SUNDRY NOTICES AND REPORTS ON WELLS

FEDERAL 33 GAS COM

CHEVRON U.S.A. RESPECTFULLY REQUESTS THAT AN APPROVAL BE MADE TO MOVE THE LOCATION OF THE SUBJECT WELL FROM 1880' FSL TO 1980' FSL AND FROM 1980' FWL TO 2080' FWL.

Re: ChevronTexaco's Fed Com '33' #3
Surface Location: 1980' FSL & 2080' FWL
Proposed BHL: 1980' FSL & 1980' FWL
Section 33, T21S, R23E, Eddy County, N.M.

WELL LOCATION AND ACREAGE DEDICATION PLAT

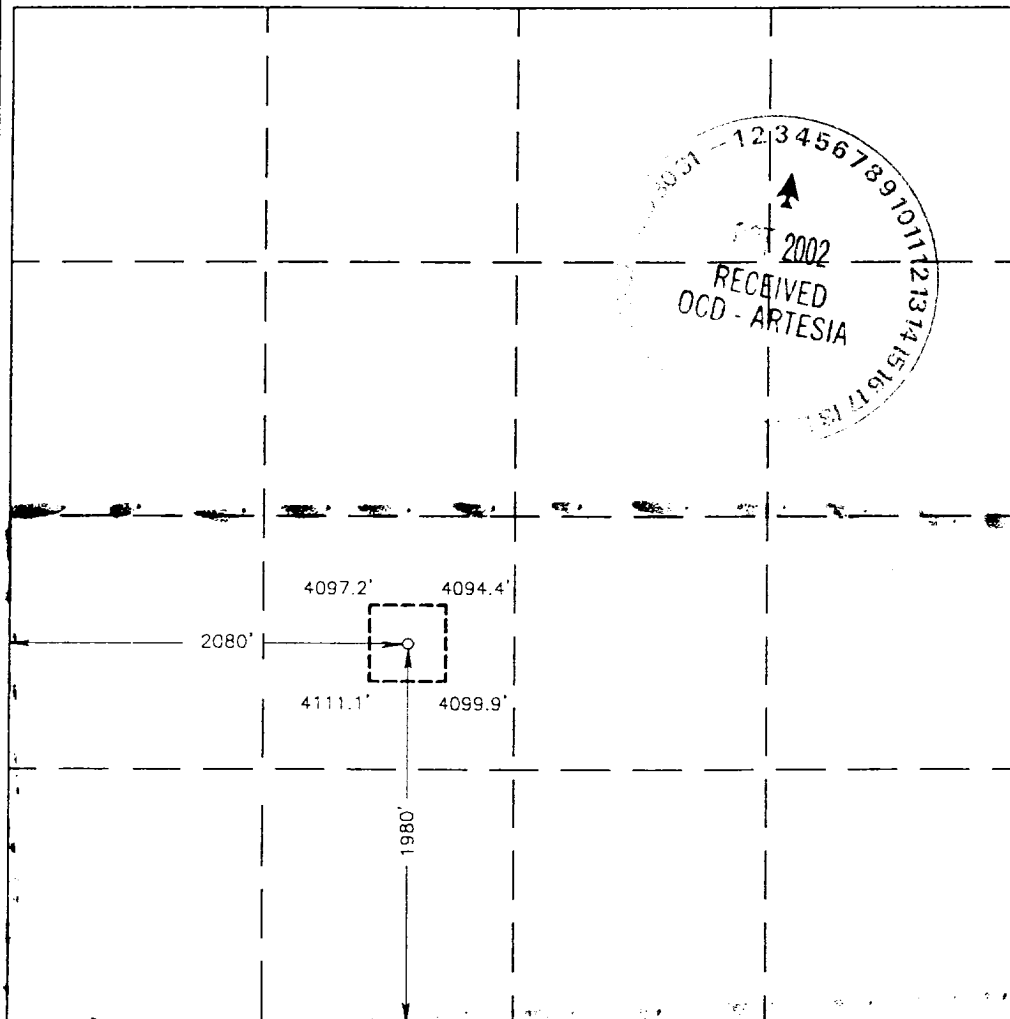
PROPOSED BOTTOMHOLE LOCATION IS: 1980' FSL, & 1980' FWL

UL or lot No. K	Section 33	Township 21-S	Range 23-E	Lot Idn	Feet from the 1980'	North/South line SOUTH	Feet from the 2080'	East/West line WEST	County EDDY
--------------------	---------------	------------------	---------------	---------	------------------------	---------------------------	------------------------	------------------------	----------------

UL or lot No. K	Section 33	Township 21-S	Range 23-E	Lot Idn	Feet from the 1980'	North/South line SOUTH	Feet from the 1980'	East/West line WEST	County EDDY
Dedicated Acres 320	Joint or Infill	Consolidation Code	Order No.
